BLUE BIRCH 1447 NW 65TH ST

DESIGN RECOMMENDATION PACKET
13 June 2022
SDCI Project #3036782-LU

RESPONSE TO BOARD RECOMMENDATION

(FINAL RECOMMENDATION OF THE NORTHWEST DESIGN REVIEW BOARD, 04.02.2018)

CURRENT PERSPECTIVE VIEW

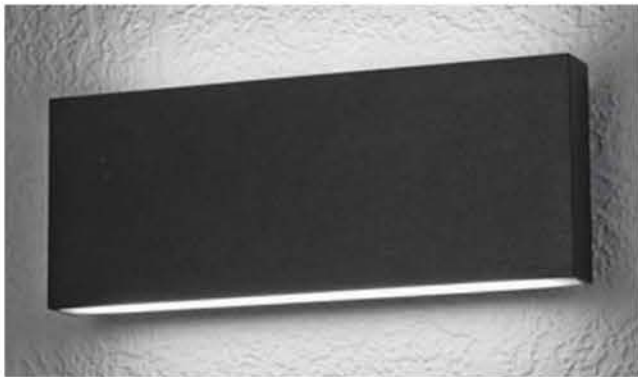
A. The Board recommended a condition to provide the vent shrouds as shown on the elevations in the Recommendation packet, especially at the brick facades. (DC2-B-1)

A. More vent shrouds added.on both fiber cement panels and brick facades.

ILLUMINATION PLAN - GROUND FLOOR

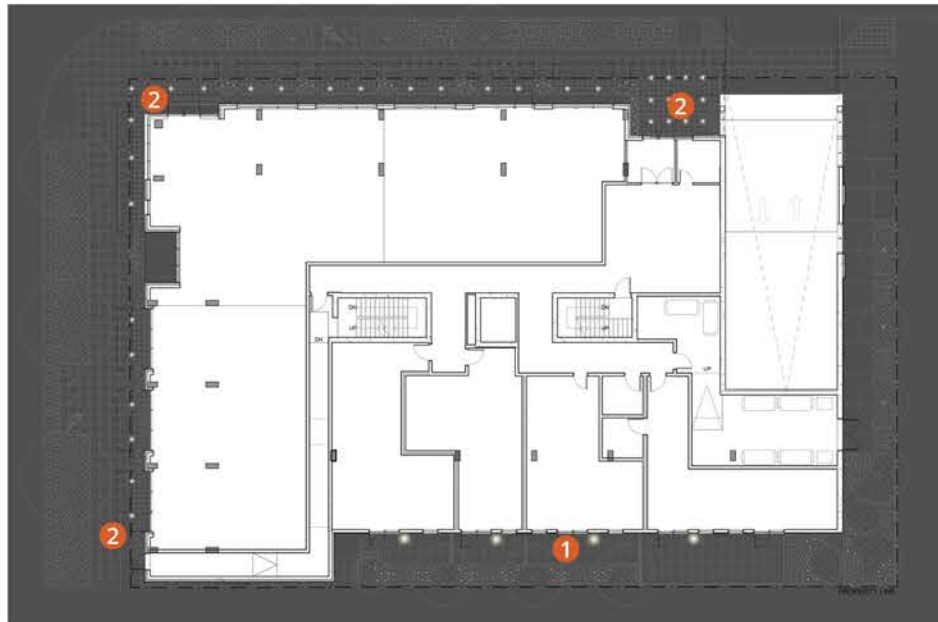
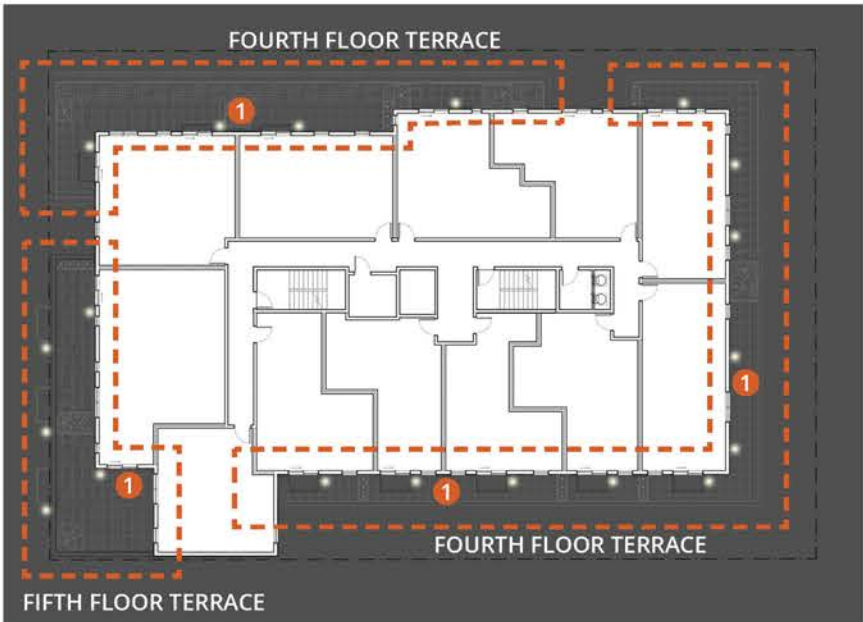
B. The Board recommended a condition to provide the lighting as shown in the Recommendation packet. Page 35 as shown above. (DC4-C)

B. The Lighting will be provided

CURRENT PERSPECTIVE VIEW

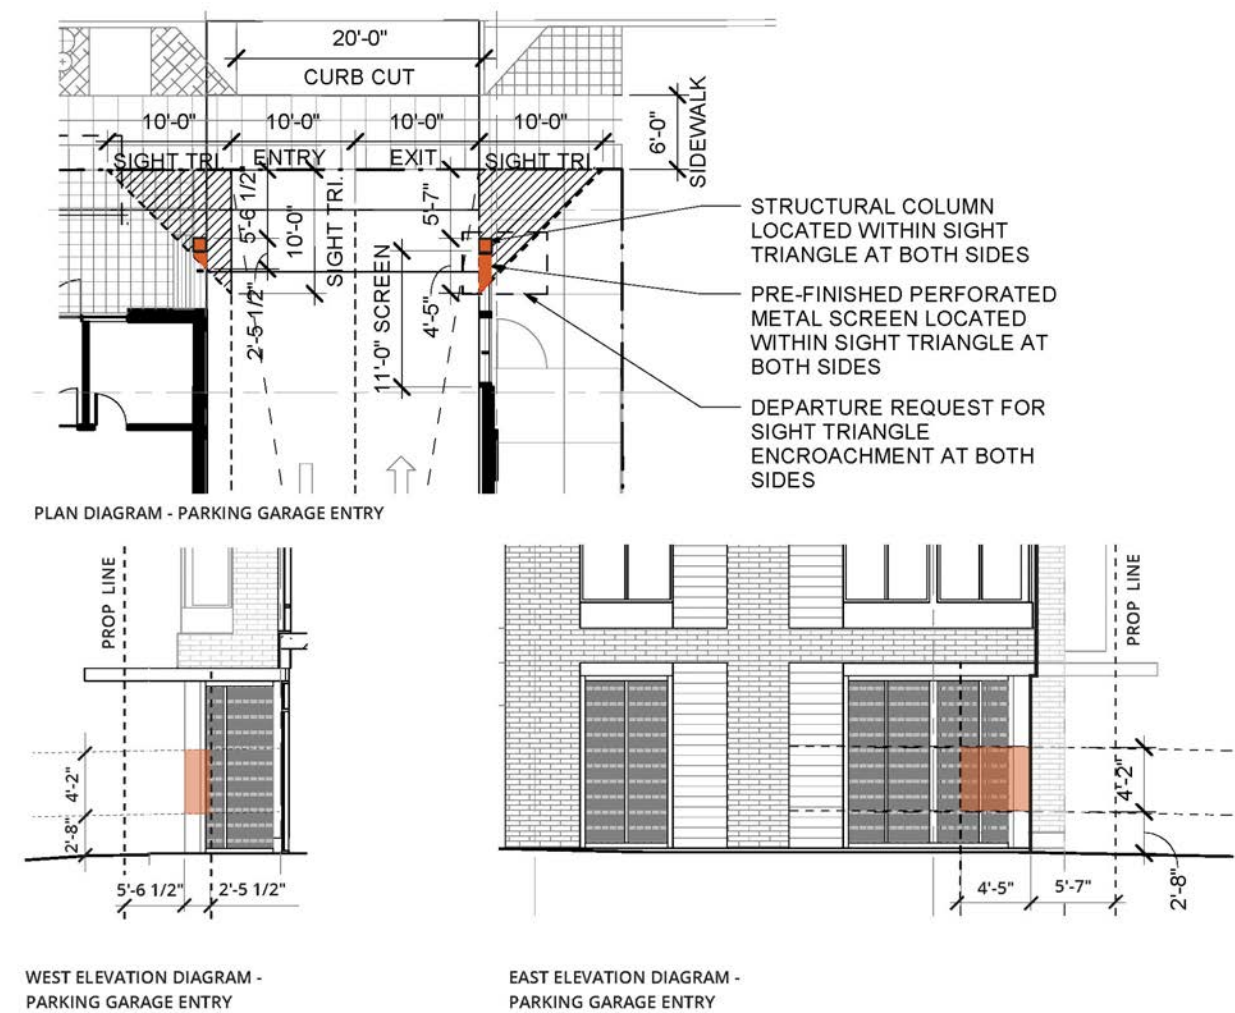
- C.** The Board recommended a condition to provide white vinyl window frames at the white Hardie facades. (DC2-B-1, DC4-A-1)
- D.** Consider having the solo balcony at the upper level along 15th Ave NW match the smaller balconies at the white upper level along NW 65th St. The Board declined to make this a condition of approval. (DC2-B-1, DC2-C-1)
- E.** Consider a solid parapet at the darker massing along 15th Ave NW to match the solid white parapet at the upper levels balanced against the parapet treatment at the brick massing as shown on page 15 of the Recommendation packet. The Board declined to make this a condition of approval. (DC2-B-1)

- C.** Vinyl window frames at the white hardie facades are changed to white.
- D.** The balconies at upper floor are all changed to juliet balconies so they match each other.
- E.** The low parapets with metal railings are retained. Though they are different from the solid white parapet at the upper levels, the semitransparent railing will provide a better view for occupants. Also, since the parapet at brick massing is lower than those at darker massing, these two massings can be visually distinguished.

CURRENT DESIGN

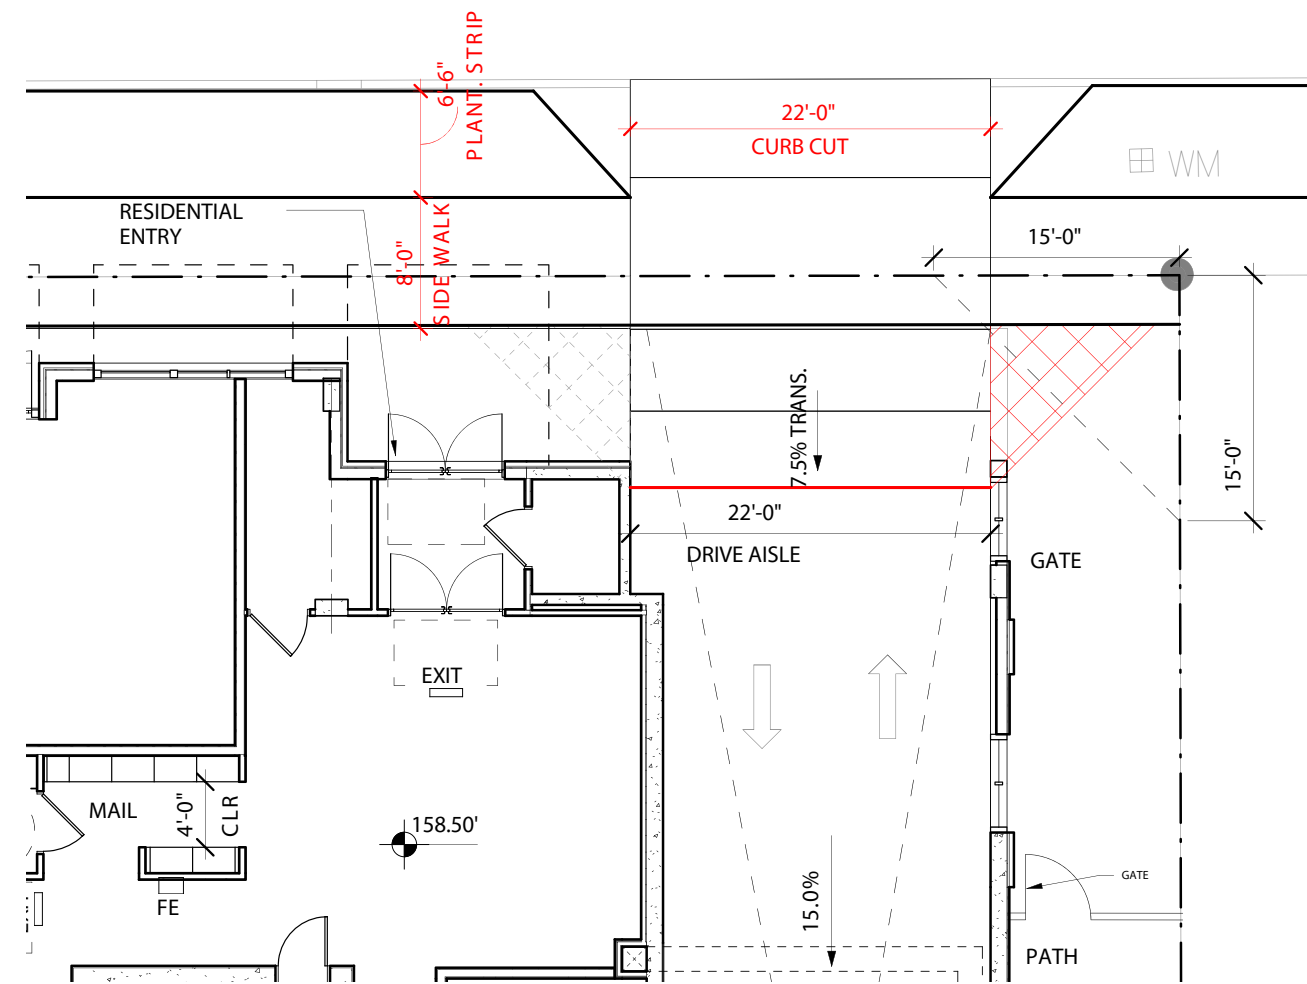
A. The Board recommended a condition to provide a 22' wide curb cut at the access along NW 65th St to below grade parking. Pull back the structure and other building elements as much as possible to be clear of the required sight triangle area. (PL2-B-1, DC1-B-1)

A. 22' wide curb cut provided and the structure was pulled back as much as possible. But in response to SDOT's SIP comments, the planting strip is 6' 6" wide (used to be 5' 6"), and the side walk is 8' 0" (used to be 6' 0"). There's a small portion of the building column intruding in the right sight triangle. Because of the 22' width, the left sight triangle is not required

SITE PLANS

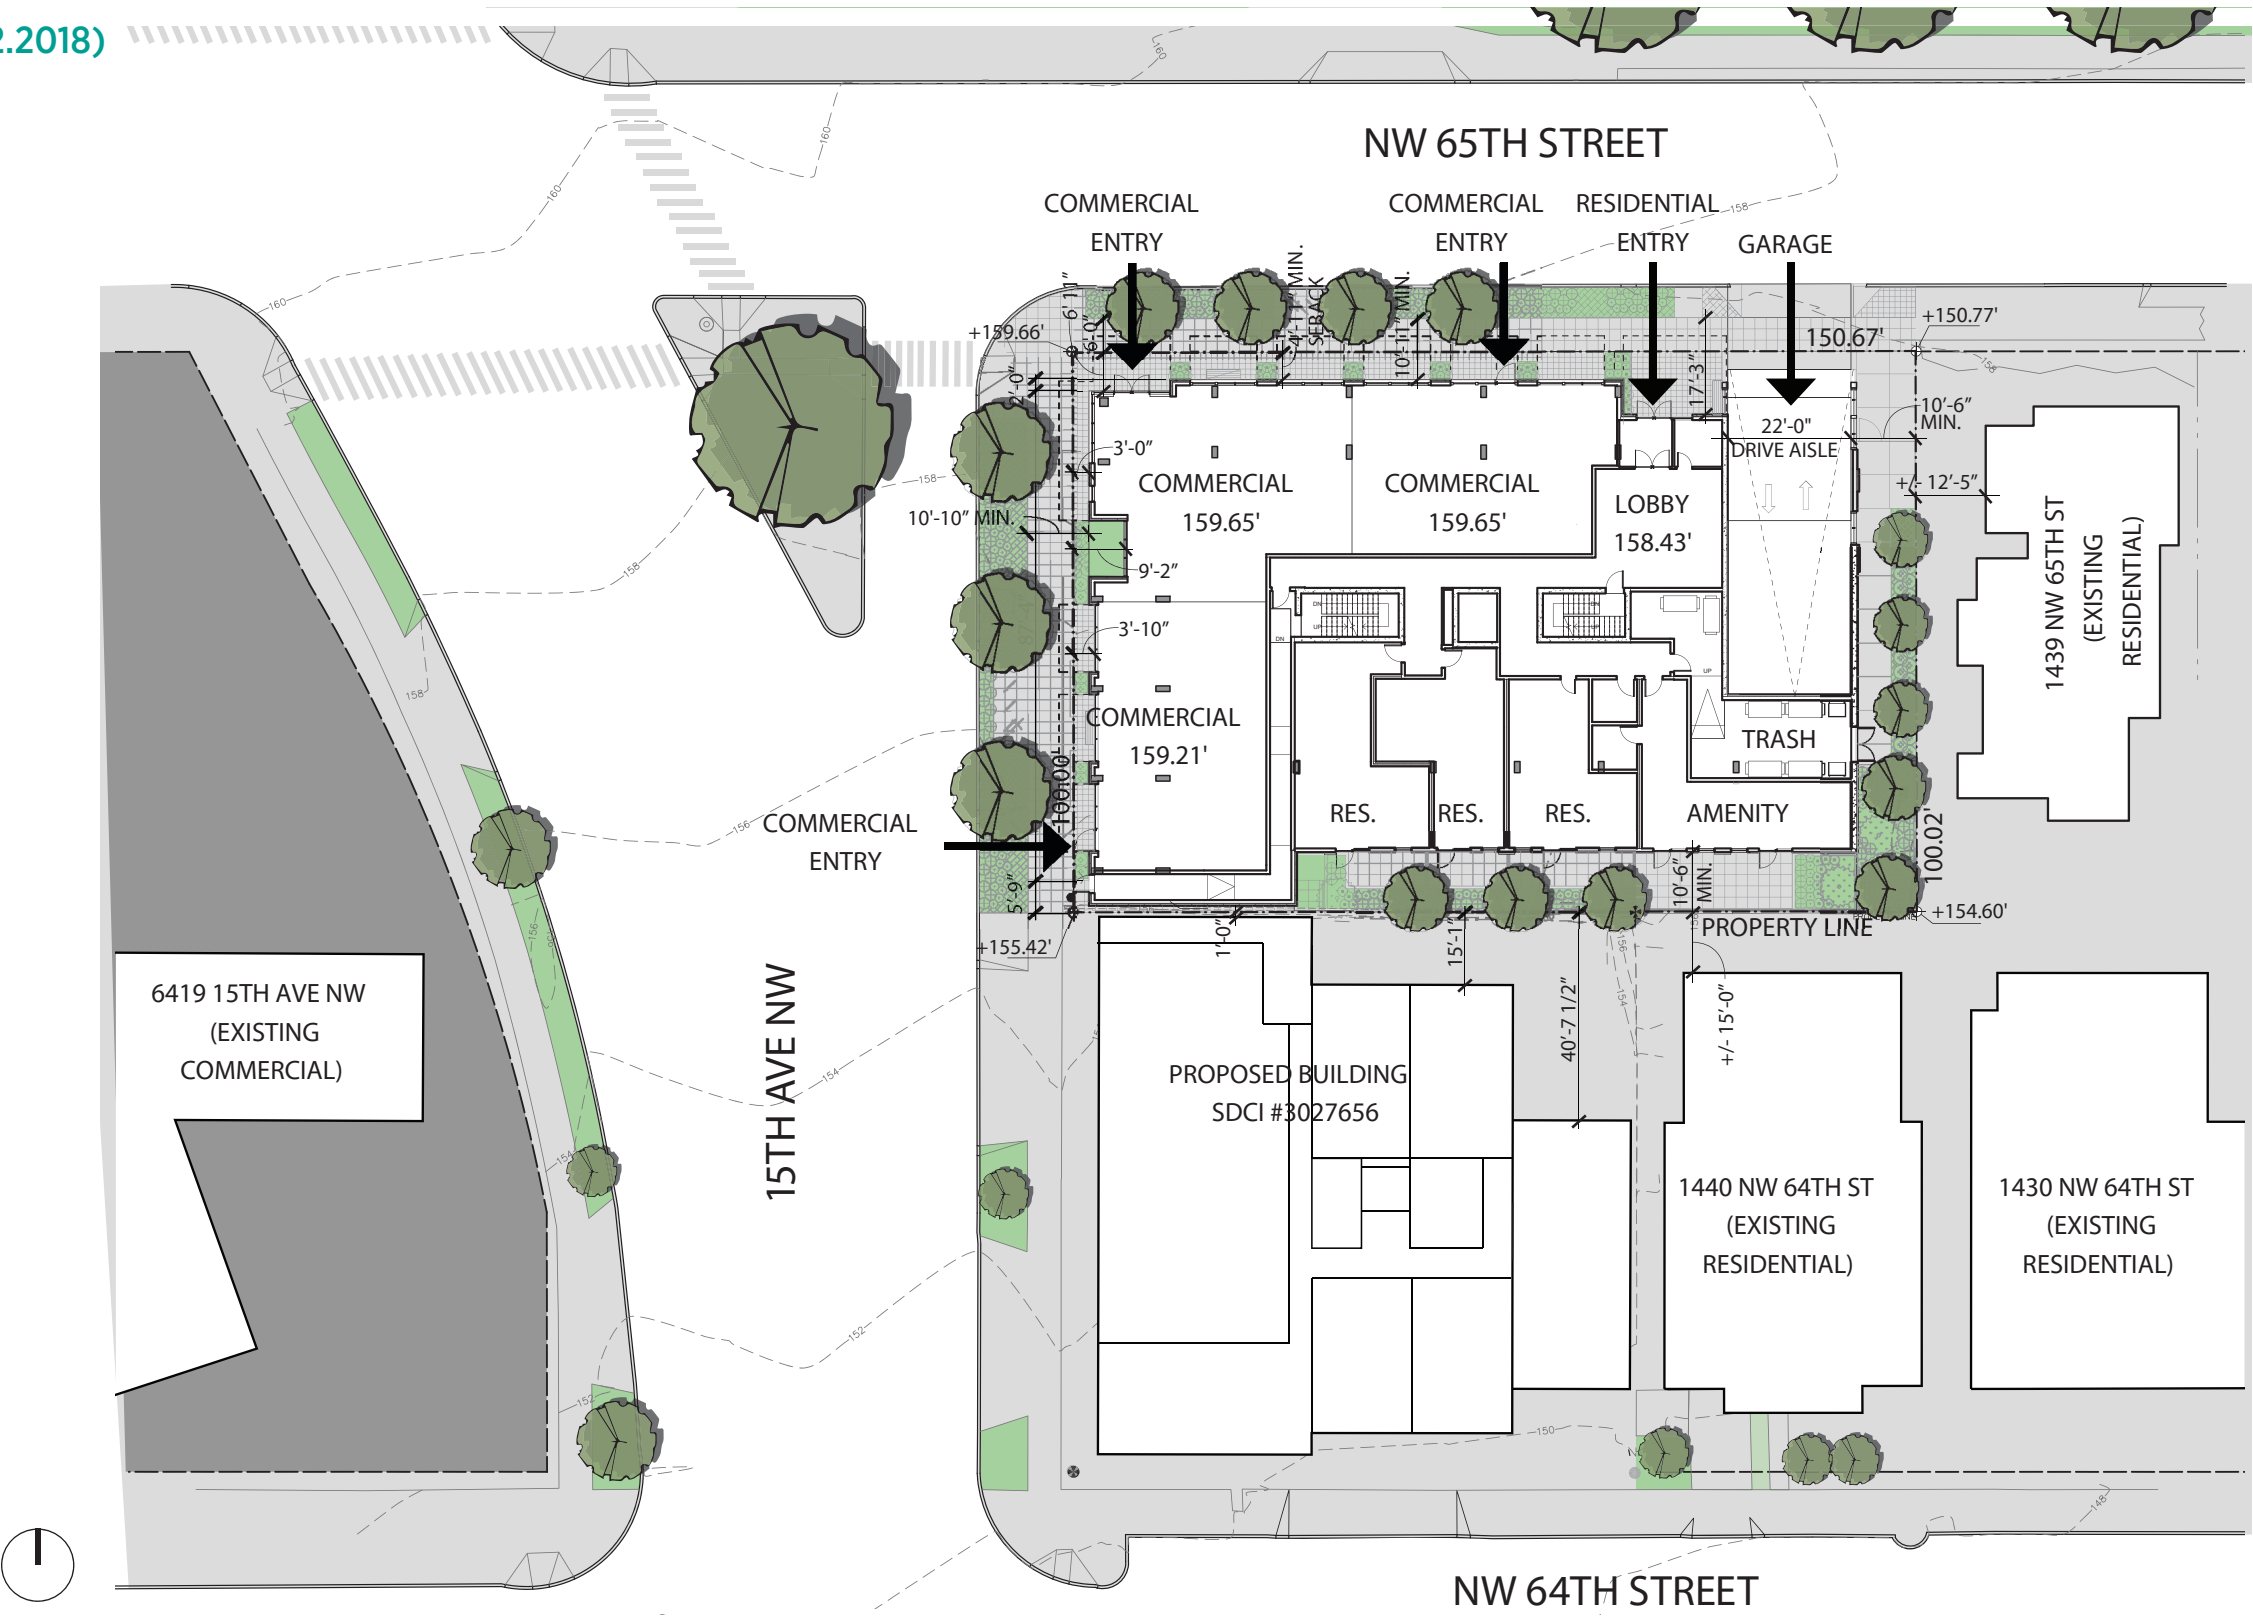
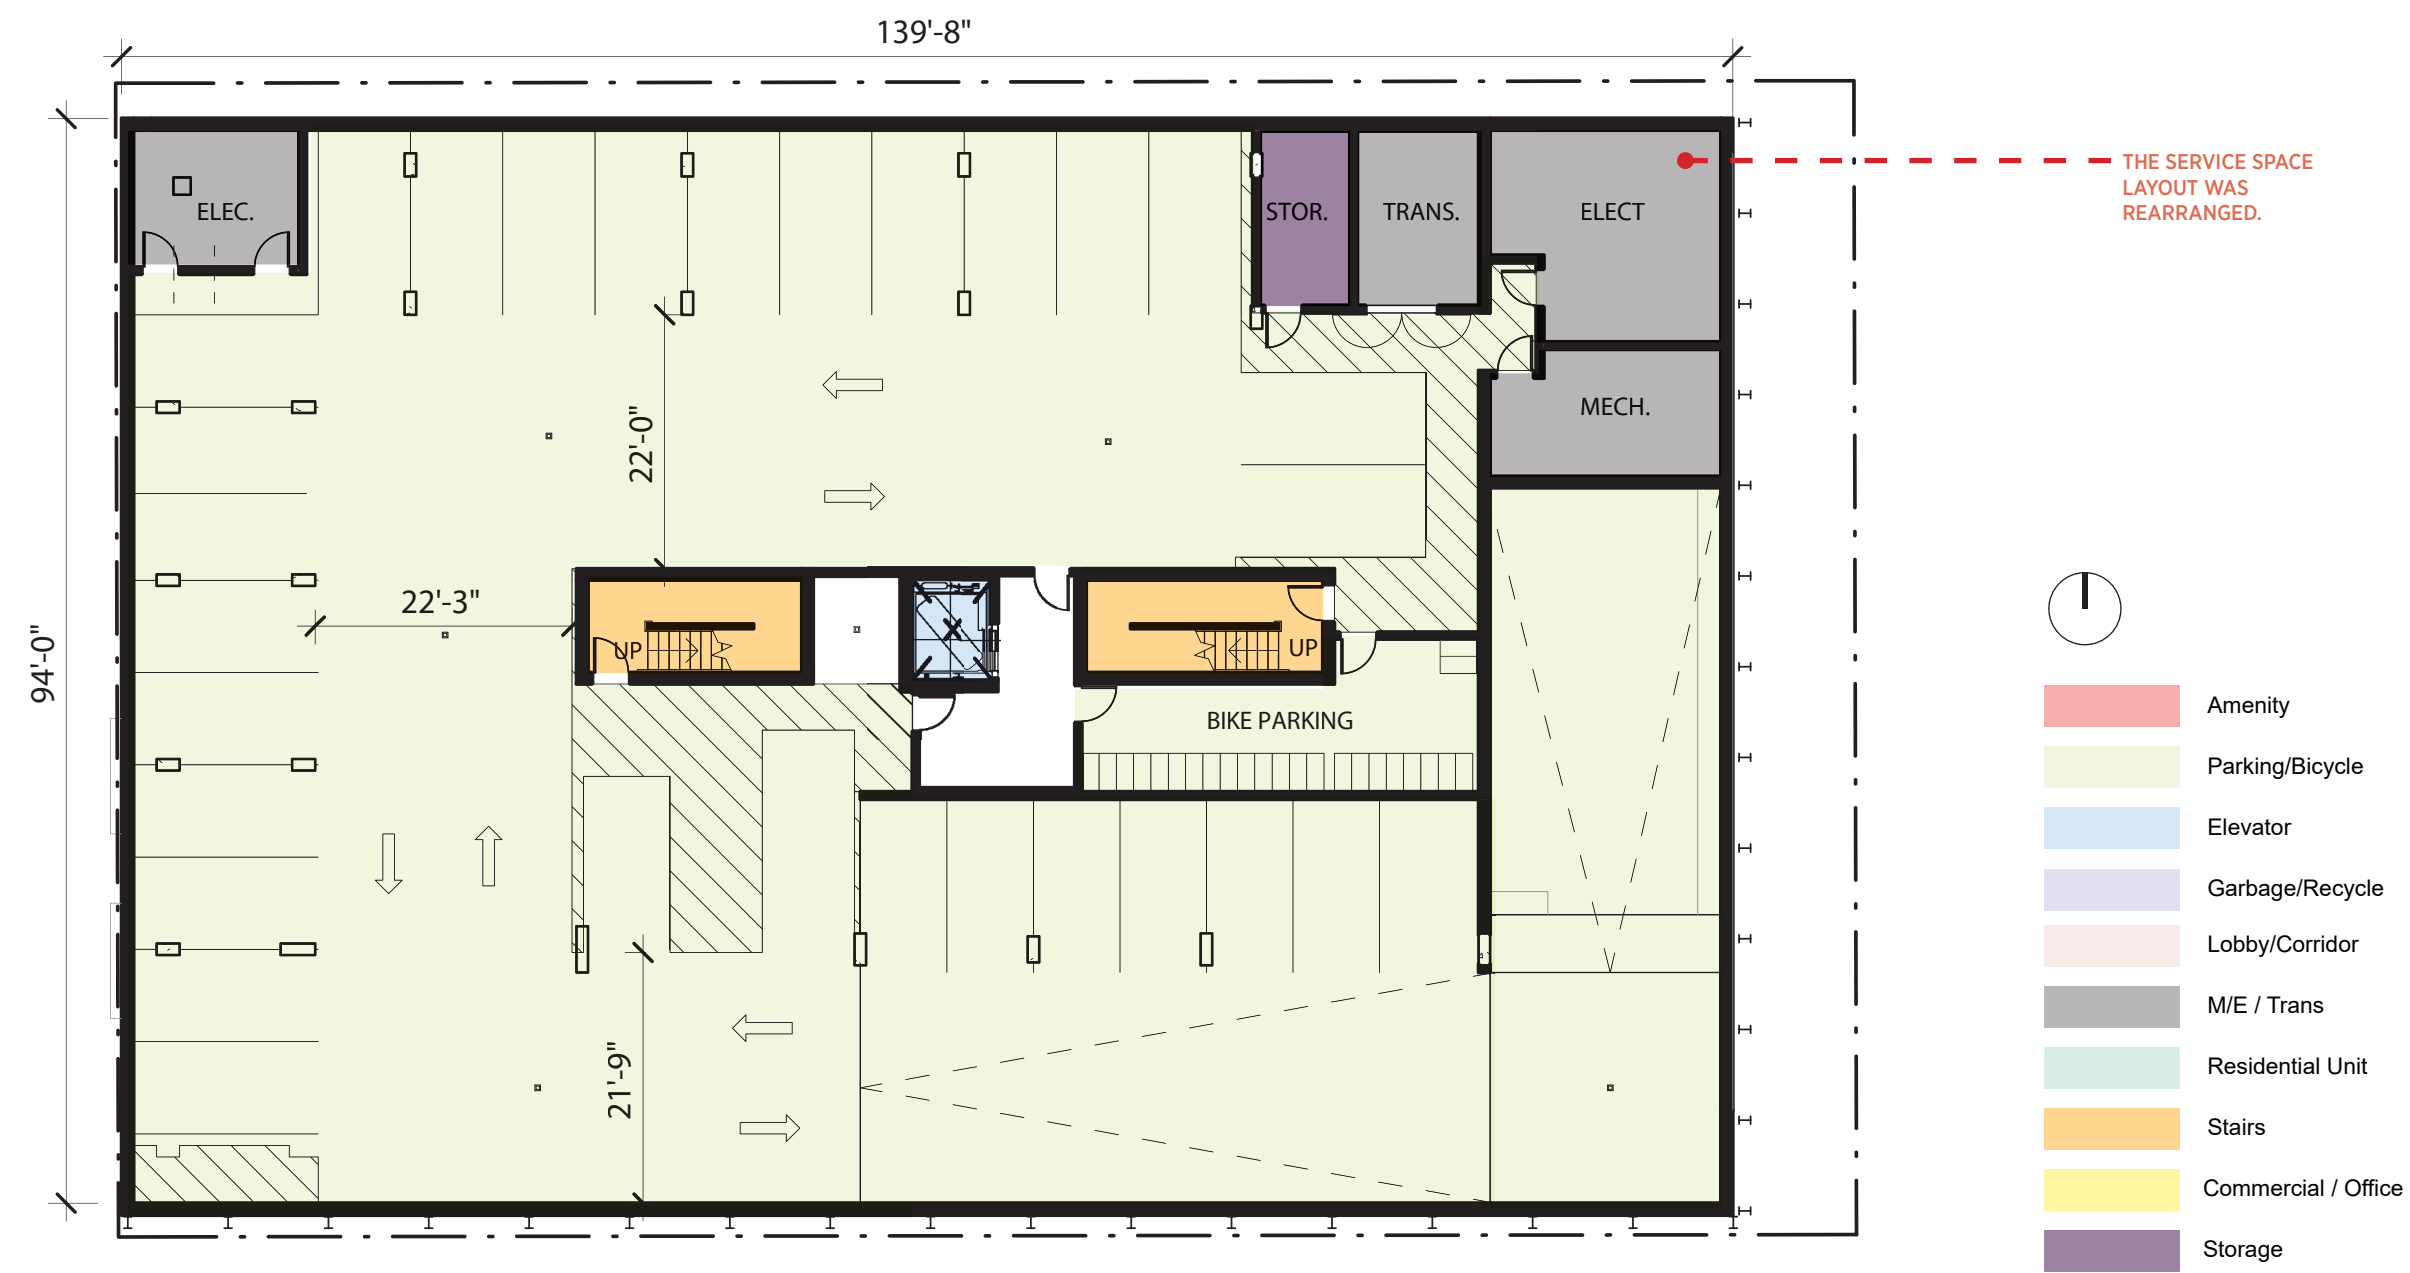
- 2' clearance needed between edge of bench and edge of sidewalk
- 8' sidewalks required on NW 65th St. Extend south leaving a 6' planting strip, 8' walk, and 1' buffer between building and edge of sidewalk.
- Confirm bike racks meet min clearances meet SDOT DR 01-2020 (pg 28) and confirm total foot print when in use does not encroach in the sidewalk.
- Doors cannot swing out into and encroach in the sidewalk, dedication, or ROW setback.
- Extend planting strip to 15th to close off 65th st crossing.
- There is an extra door shown on the landscape plans not shown on the civil at the east end of the building. It cannot swing into the 3' ROW dedication.

PLANTING STRIP EXTENDED

BIKE RACKS MEET MIN CLEARANCES REQUIREMENT, PLEASE SEE LANDSCAPE DRAWING ON PAGE 21 FOR MORE DETAILS.

DOORS DO NOT ENCRUCH INTO THE 3' ROW SETBACK.

8' SIDEWALKS AND 6'-6" PLANTING STRIP PROVIDED ON NW 65TH ST, AND THERE IS 2'-2" BUFFER BETWEEN BUILDING AND EDGE OF SIDEWALK.

REVISED GARBAGE/ RECYCLE/COMPOST PICKUP TO INCLUDE STAGING AREA BEHIND GATE. APPROVED BY SPU.
